ADDENDUM NO. 1 – December 9, 2016

**RE: WINDOW REPLACEMENT AND ASSOCIATED WORK
WATERTOWN MIDDLE SCHOOL
WATERTOWN, MA
GALE JN 830680**

Window/Insulated panel and Louver detail

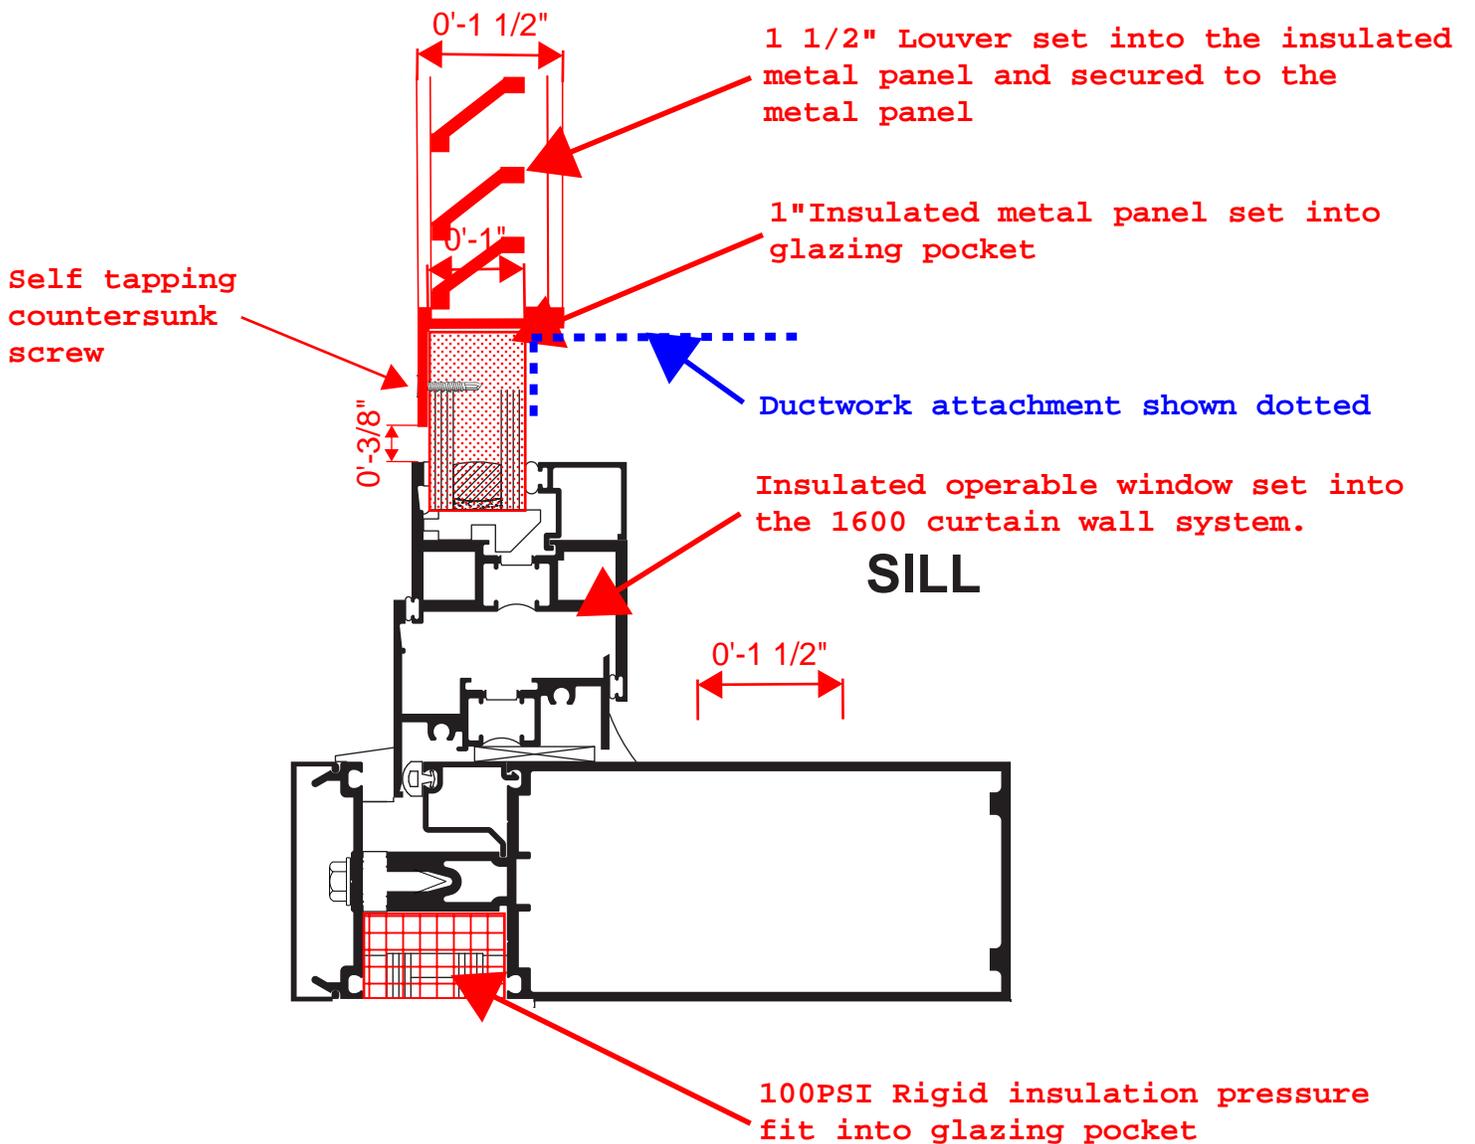
Modification: Refer to Section 23 00 00 – 2.2A of the Contract Specifications. The last two sentences of the specifications section states “Size shall be as designated on the Contract Drawings to fit within the new curtain wall assemblies or insulated metal panels. Louvers shall be glazed into the curtain walls.” Replace these sentences with “Louver size shall match the existing louver size to provide the same amount of free air as the existing units, at a minimum. Louvers shall be secured to insulated metal panels, as detailed.” The louver attachment to metal panels is detailed in Attachment #1 to this Addendum. Note that it is anticipated that duct extensions will be required to attach new louvers to existing ducts at the typical unit ventilator locations. Refer to Contract Documents for duct extension specifications. Details of unit ventilator/duct attachment to existing conditions was not provided by the Town of Watertown. The unit ventilator systems must remain in place during the project.
